Product change notification (PCN)

Title / short description	Implementation of digital documentation and product marking update for the RIFLINE complete series
Affected article category	Relay modules
Change category	Marking, Documentation
Change number	CDK260056-00
Reason for PCN/PDN Revision

CDK260056

Implementation of digital documentation and product marking update for the RIFLINE complete series

old design

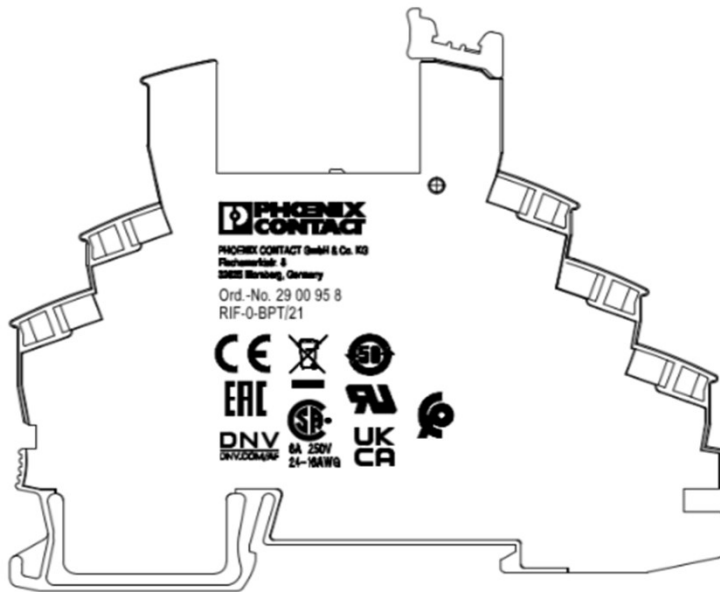
The conformities and approvals for RIFLINE complete products are being updated. Therefore, the product labeling (printing layout) will be changed.

The EAC and UKCA markings will be removed from the product labeling.

In addition, a QR code will be added to the product marking. The QR code provides easy access to all relevant documents, technical data, and certificates in one central place.
